Safety Evaluation Report

related to the operation of
Midland Plant,
Units 1 and 2

Docket Nos. 50-329 and 50-330

Consumers Power Company

Figure 2.5 Auxiliary building underpinning plan and section
(Source: FSAR Figure 3.8-61A)

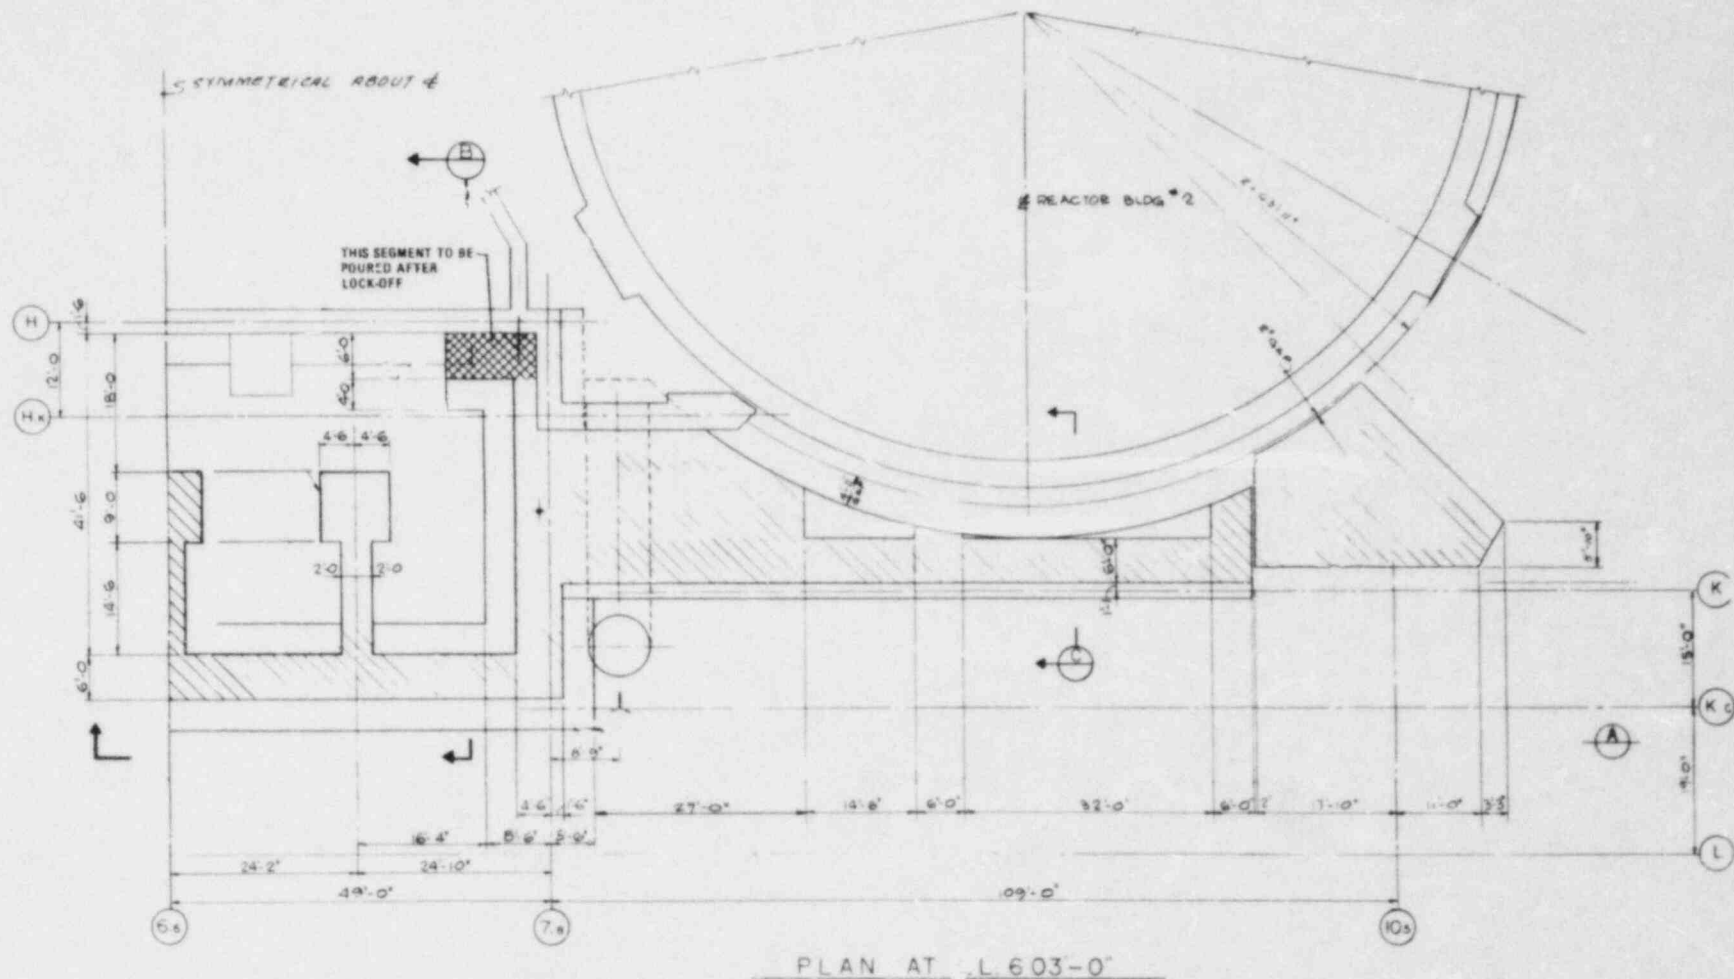
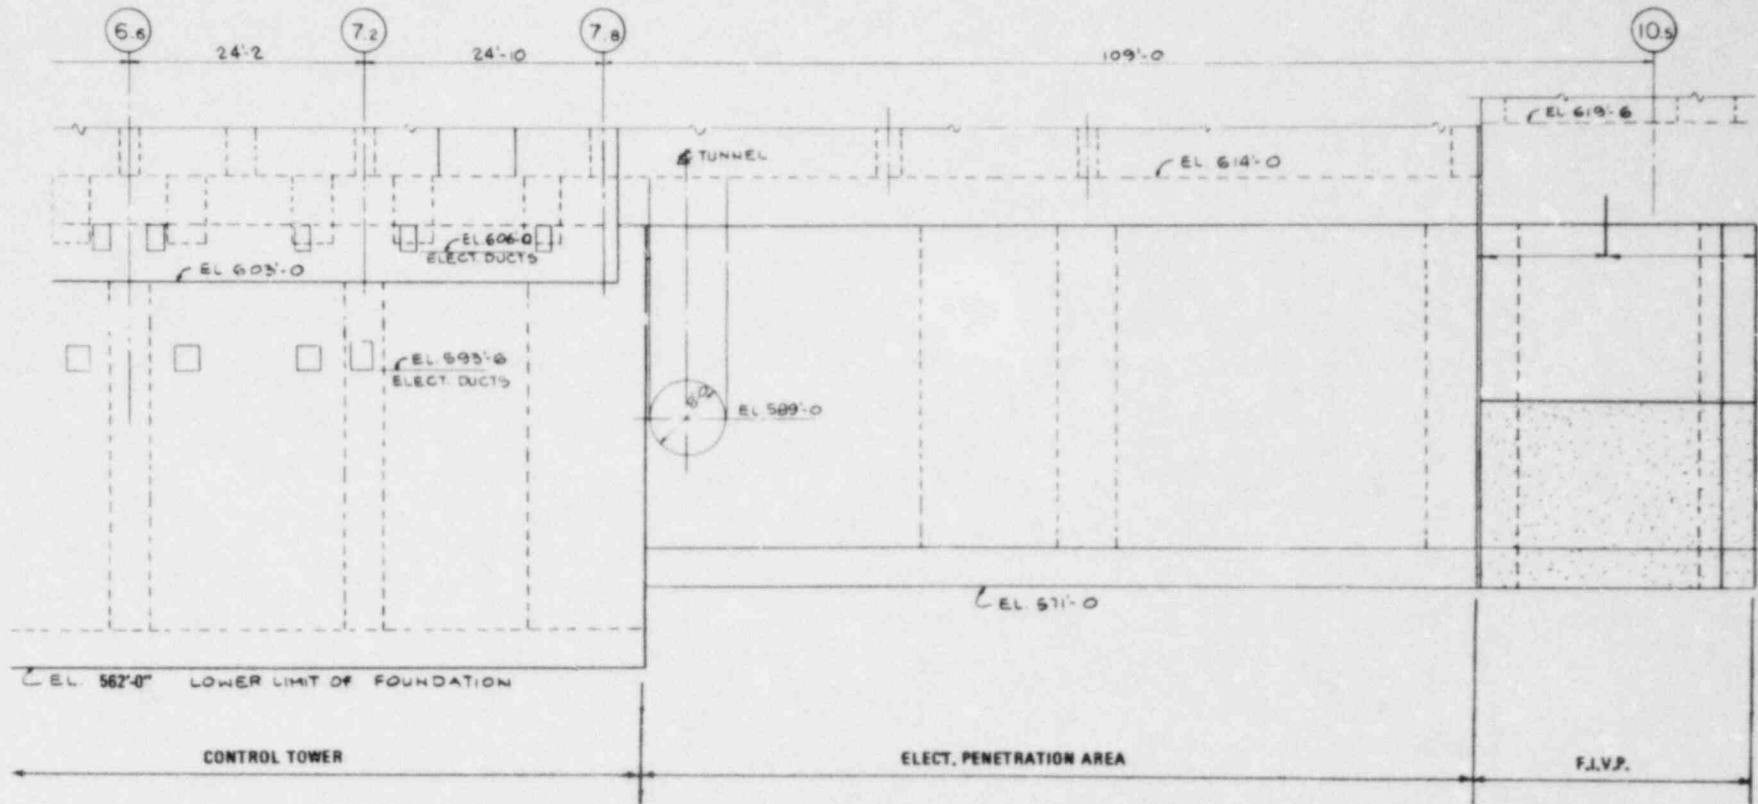
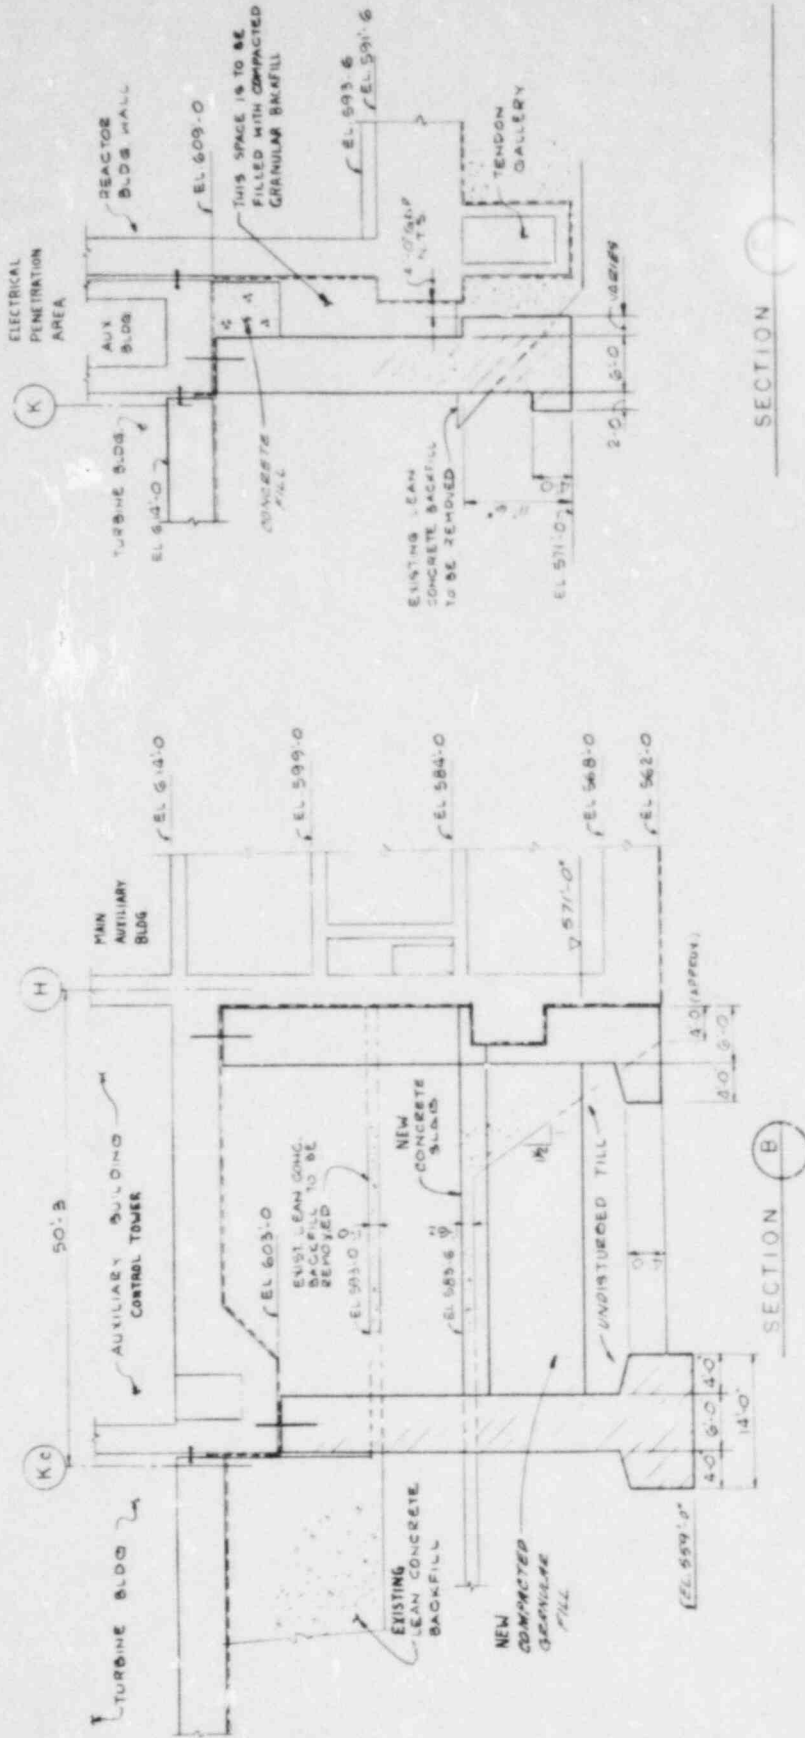
To ensure long-term foundation stability, the applicant has proposed to underpin the CT and EPAs with a new permanent underpinning wall that will extend through the plant fill to the competent hard clay natural soil on which the main auxiliary building is also founded. Plans and section views of this underpinning for the auxiliary building are shown on Figure 2.5 of this SSER. The permanent underpinning wall will be connected to the bottom of the existing mat foundations (and to the main auxiliary building beneath the CT) after the structure load has been held long enough with jacks on the underpinning to reduce future settlements to minimal values. Details of the connection for the underpinning walls are shown on Figure 2.6 of this SSER.

Figure 2.7 Feedwater isolation valve pit support
 (Source: FSAR Figure 3.8-85)

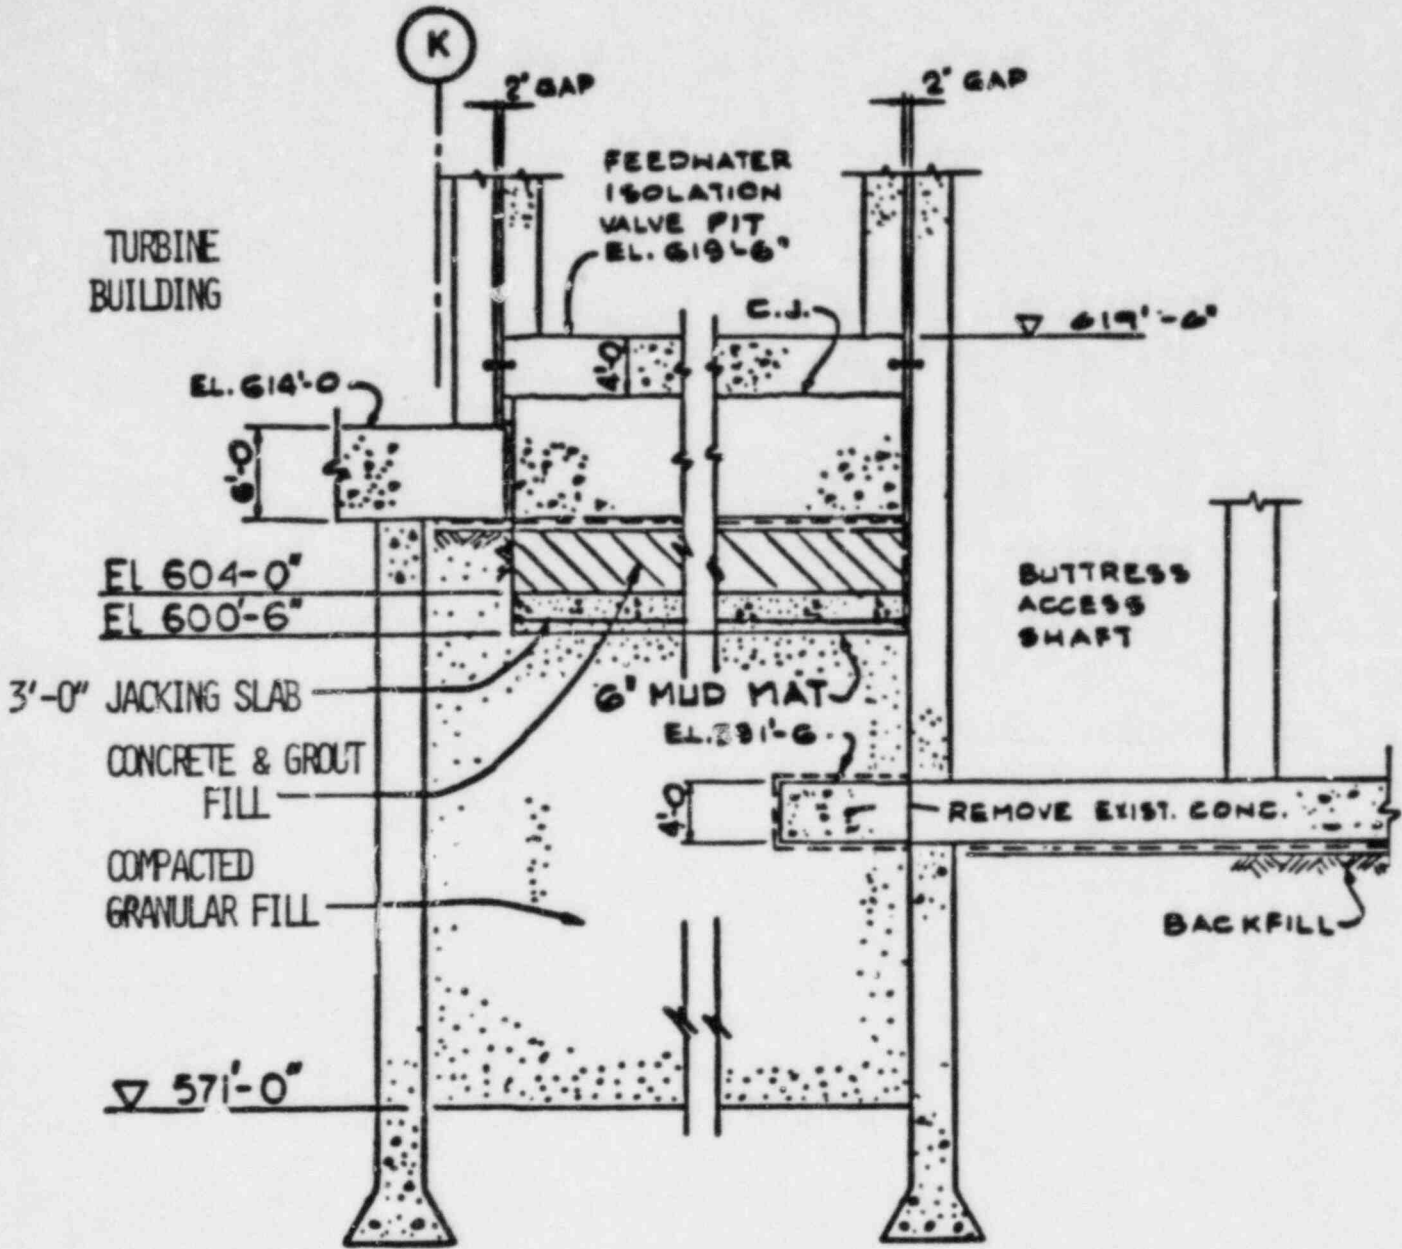
Foundation treatment for the inadequate plant fill beneath the FIVPs consists of excavating the fill and a portion of the hard clay and replacing it with approximately 30 ft of compacted granular fill and 4 ft of concrete fill. Figure 2.7 of this SSER shows the resulting support. The granular fill is to be compacted to 95% of maximum dry density, as determined by ASTM test D-1557 or ASTM test D-2049, whichever results in the greater maximum dry density. The granular fill has been specified and is to be compacted with proper equipment and control of placement water. The applicant has committed to following a test procedure for controlling compaction that is acceptable to the staff.

The granular fill and the concrete beneath the FIVPs will be separated by a jacking slab that will be used to remove the load of the FIVP structures from the existing temporary overhead supports and place it on the granular fill. Thus, most of the settlement of the granular fill will occur while the jacks are in place and before transfer of the final load to the permanent foundation

is completed. Subsequent settlements are anticipated to be minimal. The FIVPs currently are temporarily supported by an overhead steel structure that is bolted to the existing concrete structure. The overhead structure transfers the load to the adjacent turbine building and containment buttress access shaft.
